UNITED STATES ENVIRONMENTAL PROTECTION AGENCY
REGION IX
75 Hawthorne Street
San Francisco, CA 94105-3901

Re: Technical Evaluation Comments and Information Request of CES's Responses to
EPA's Initial Technical Evaluation Comments and Information Requests #1-4
CES-Mendota Site Underground Injection Control (UIC) Permit Application
Class VI Pre-Construction Permit Application No. R9UIC-CA6-FY20-1

Evaluation of Applicant Responses to EPA's Technical Review Comments on the Geologic Information in the CES-Mendota Class VI Permit Application

Figure 2c and 2d: San Joaquin basin depositional model showing three possible depositional scenarios for the location of Mendota_INJ_1. Modified from (Hosford Scheirer & Magoon, 2007)

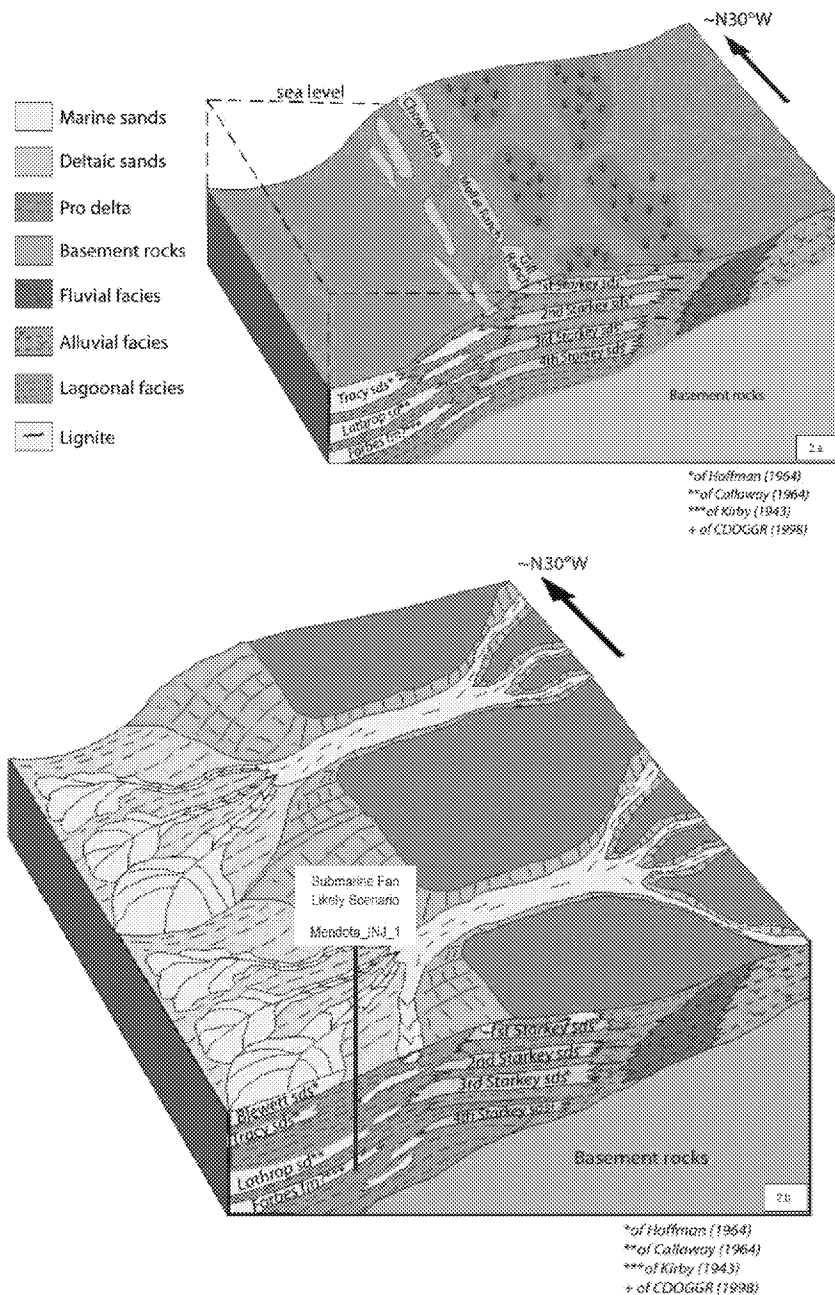
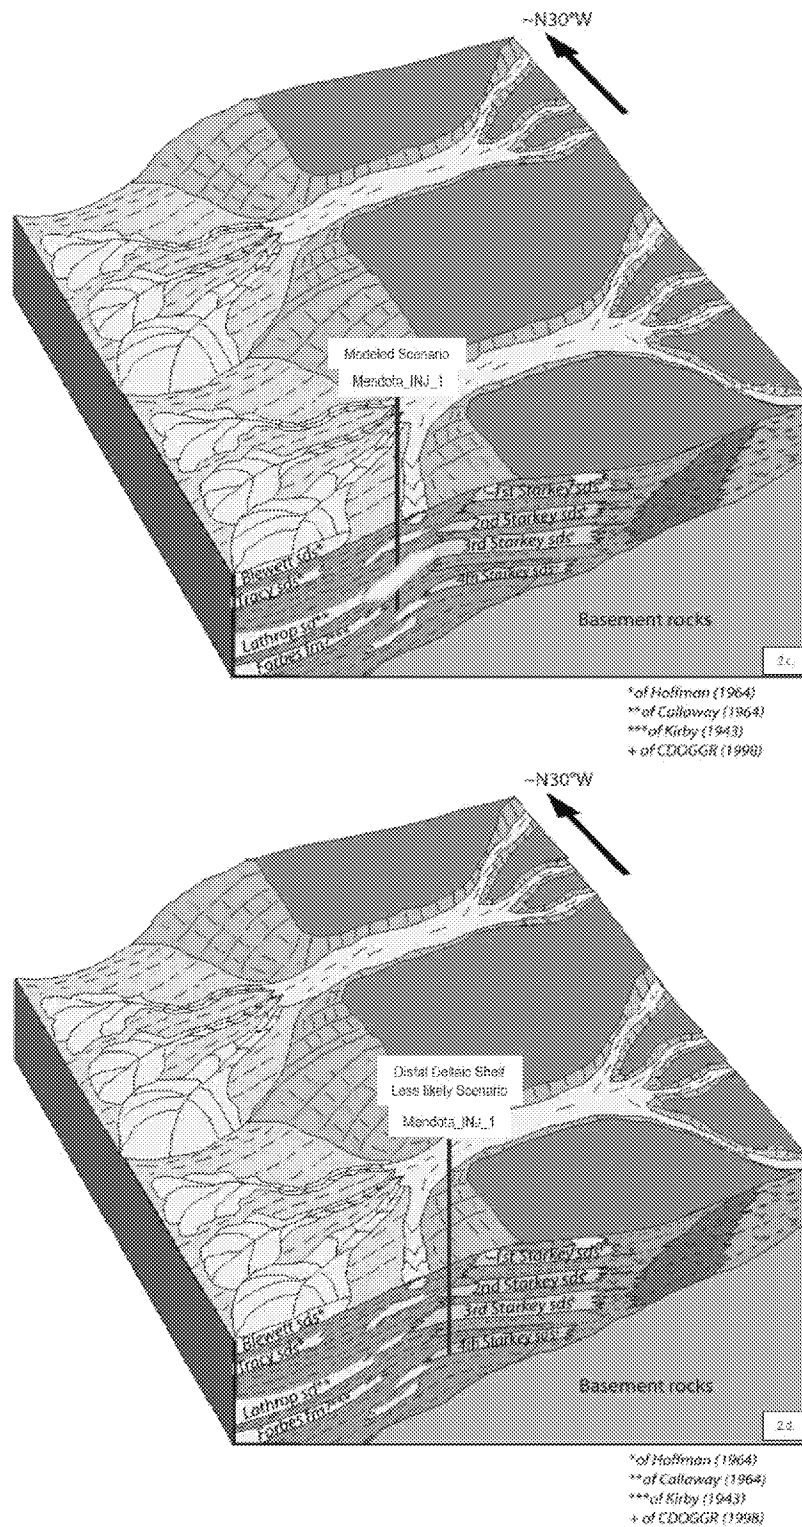
- Regarding the locations of the Mendota INJ_1 well in Figures 2a – 2d, are they supposed to be the same? They appear to be in slightly different locations within the block diagram. Is this intended to simply represent uncertainty in where the sands pinch out?
- Is the 2nd Starkey the same as the 2nd Panoche? If so, then is it coeval with the Tracy sands? The diagram in Figure 2c (modeled scenario) shows the well penetrating the level of the 3rd Starkey. In the “likely scenario” in Figure 2b, it appears that the well goes as far down as the level of what might be the 4th Panoche sand. Although the 3rd and 4th Panoche sands are potential injection scenarios, should the diagrams in Figures 2a-2d represent the planned injection into the second Panoche?

Figure 3: Porosity-permeability crossplot model cells colored by formation (from Petrel 2019).

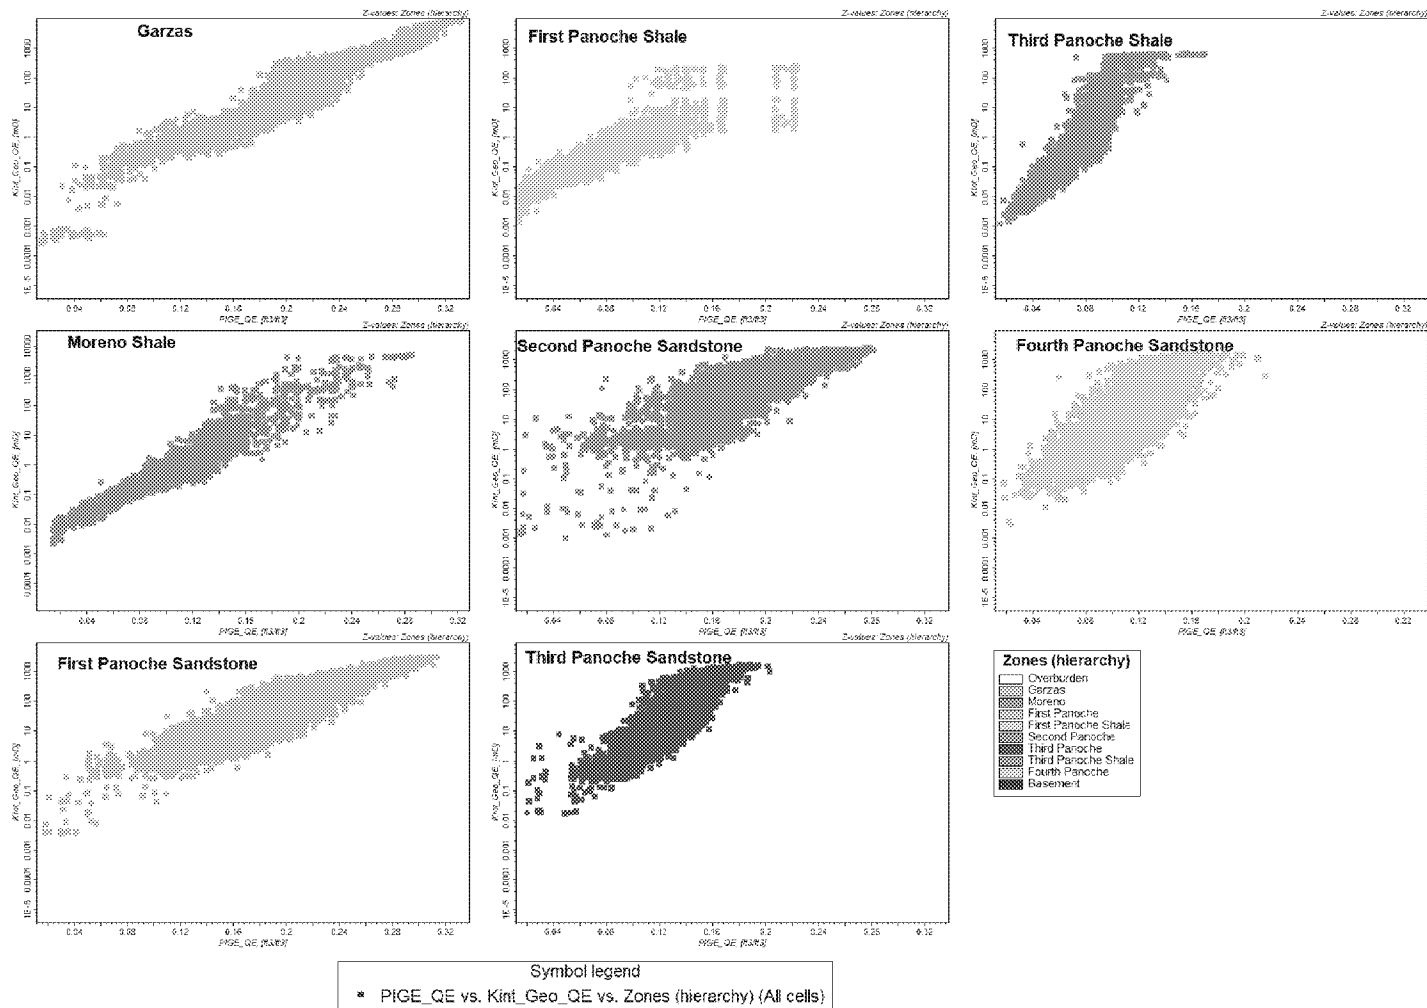
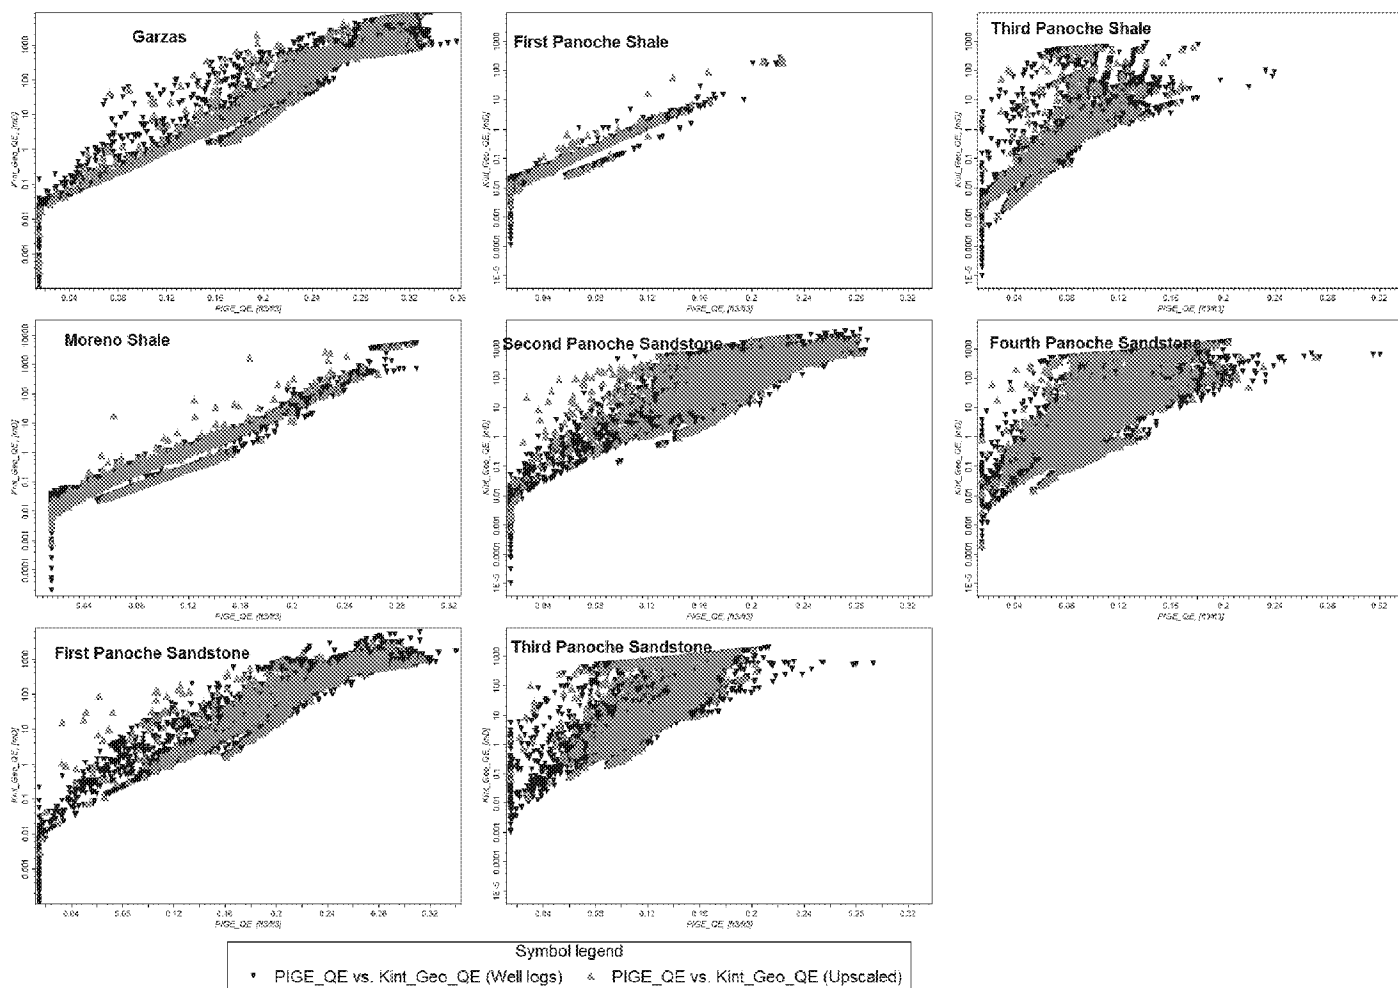
- In the plot of well log-derived data points, upscaled values, and full-field simulated cells, the upscaled values dominate. It appears that the upscaled value symbols may have been layered over the other symbols. Please revise the figure to show the distributions of all three types of data points more clearly.
 - *For clarity, Figure 30 has been subdivided into three figures. Please refer to Figure 3, Figure 4, and Figure 5 in Appendix A.*

Figure 5: Porosity-permeability crossplots of well logs vs. facies type (sand and shale) (from Petrel 2019).

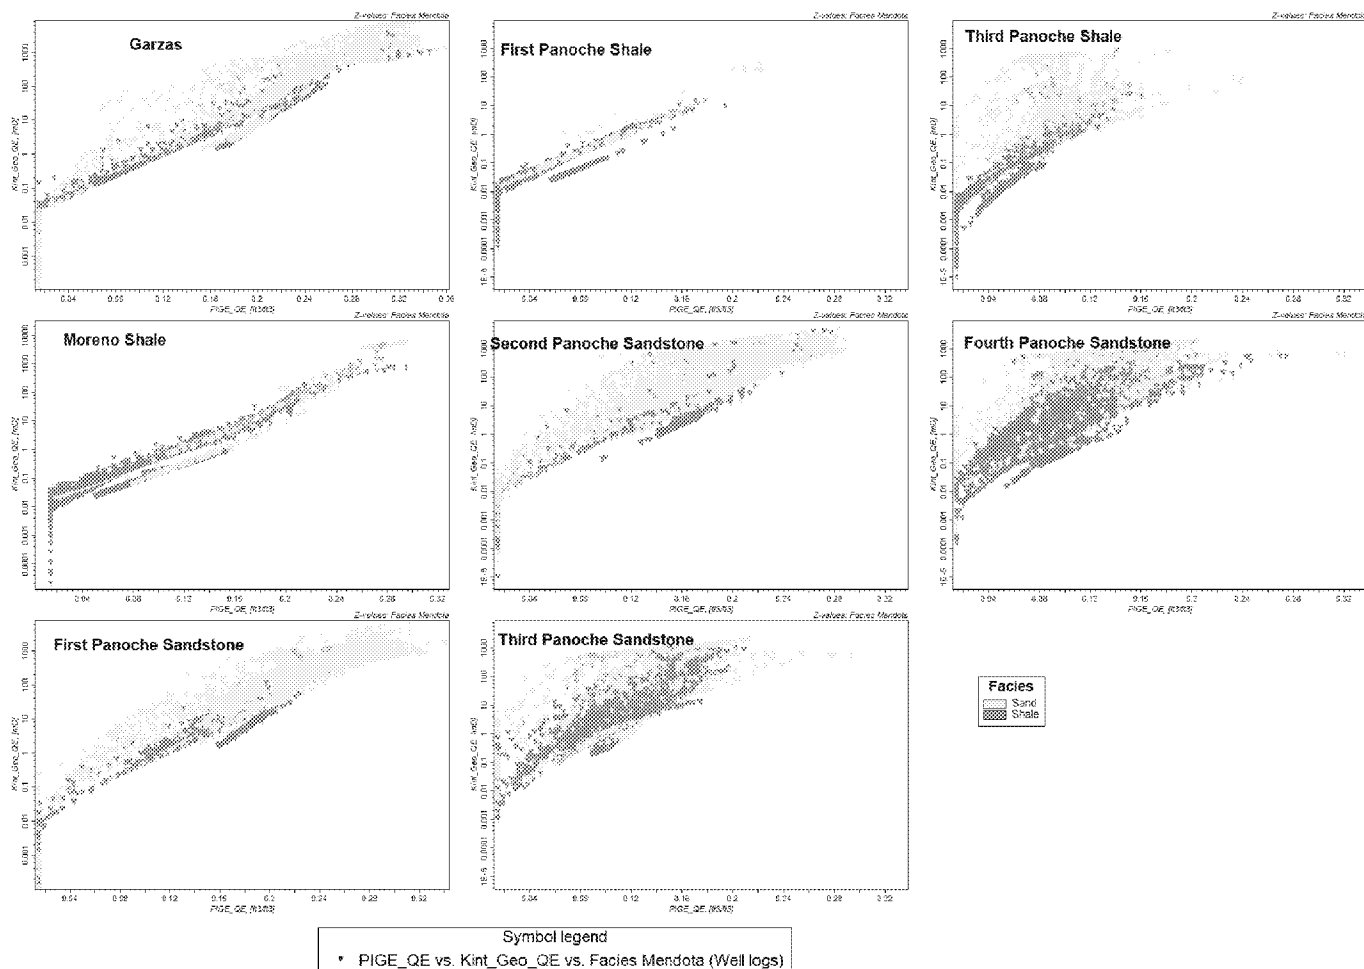
- Please clarify the meaning of the zones in the legend of Figure 30. Are they equivalent to the formations, as suggested by the legend?
 - *Zones are equivalent to formations. For clarity, Figure 30 has been updated and divided into Figure 3, Figure 4, and Figure 5 in Appendix A.*

- Why was the information shown in Figure 30 of the narrative not used as the basis for assigning these curves?
 - *The facies model described in Figure 30 (updated with Figure 5) was a preliminary estimate to perform fault seal analysis. This facies log was not used as part of the petrophysical model interpolation. The rock classification methodology (neural network) was used to create the hydrofacies interpretation needed for dynamic modeling. Porosity and permeability of the geocellular model were upscaled to a tartan grid used for dynamic modeling. Please refer to Figure 6 in Appendix A.*

- *The rock types presented in Figure 30 of the narrative, which are updated in Figure 5, were used for fault seal analysis. The petrophysical property interpolations were completed on a zone-by-zone basis and did not use these facies types in the petrophysical modeling. For example, the unique petrophysical properties (Figure 3) for the Fourth Panoche Sand are accounted for in zone-specific petrophysical modeling. After well log data are acquired, the rock typing will be calculated using a more advanced methodology such as HRA. Likely, this analysis will focus on three to five different rock types, thus enabling characterization of the Second Panoche Sand and other potential injection sands. Different shale classes will be informed by core mineralogy and digital log responses for various shale seals such as the First Panoche Shale (primary) and Moreno Shale (secondary).*

Figure 6. Rock types along the E-W cross section (from Petrel 2019).

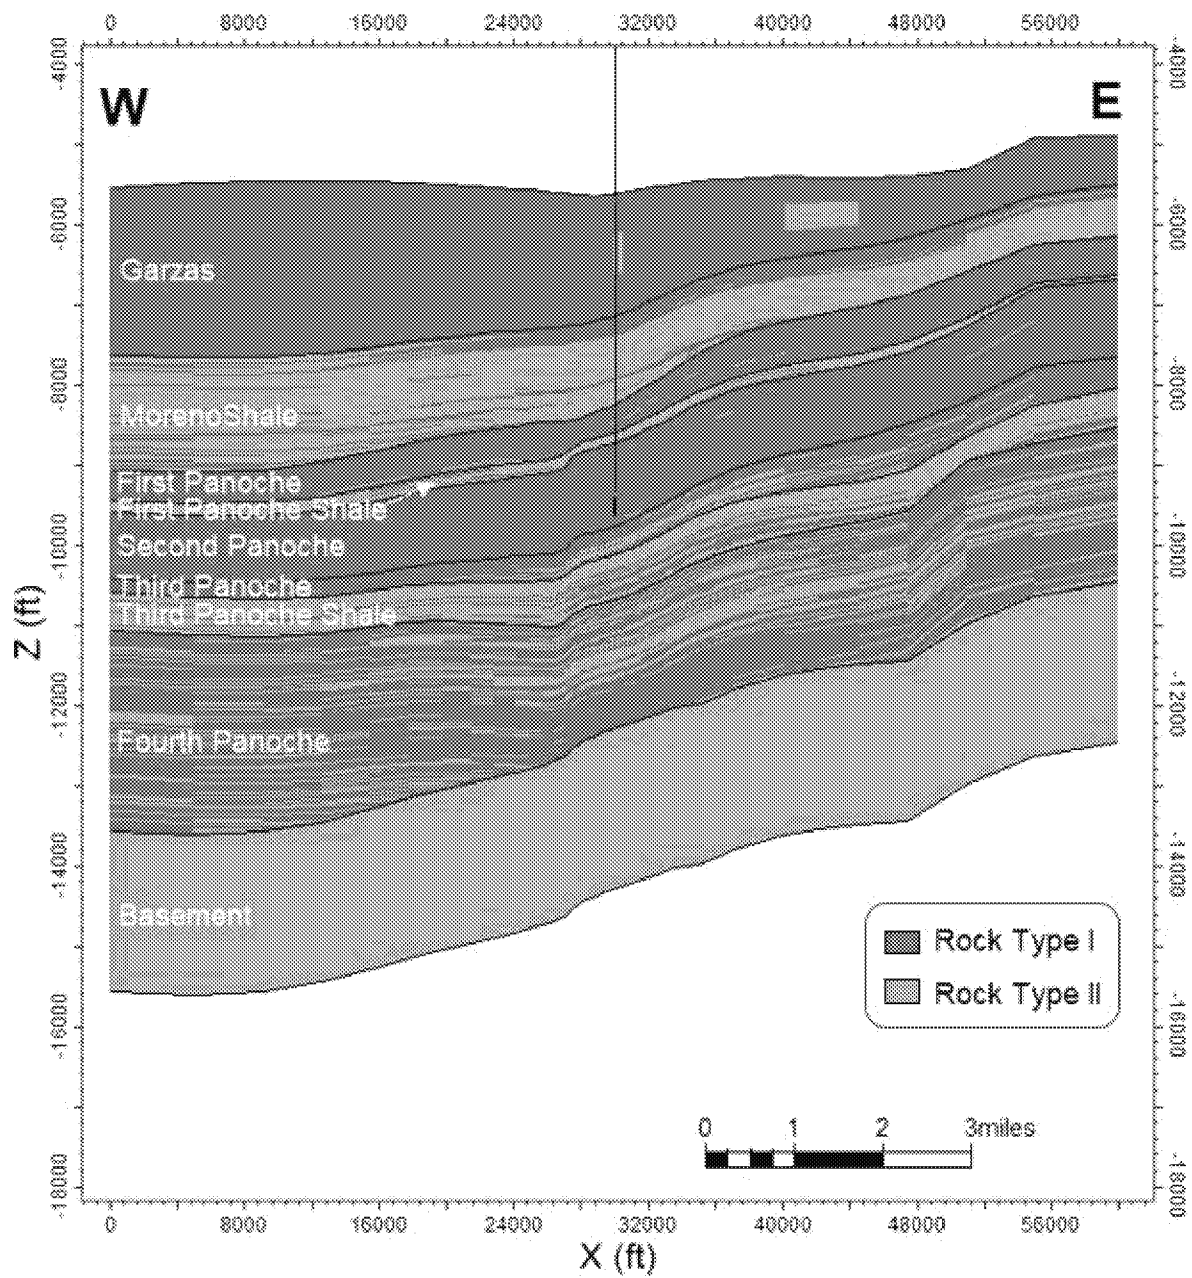
- Is there a difference between the two shades of blue in Figure 2 of the Rock Types file?
 - *No, the different blue shades are due to the presence of grid lines shown on the figure. Refer to Figure 6 in Appendix A for an updated version.*

- Please label the formations in Figure 2.
 - *Refer to Figure 6 for an updated version of Figure 2 in Appendix A which includes the formation names.*
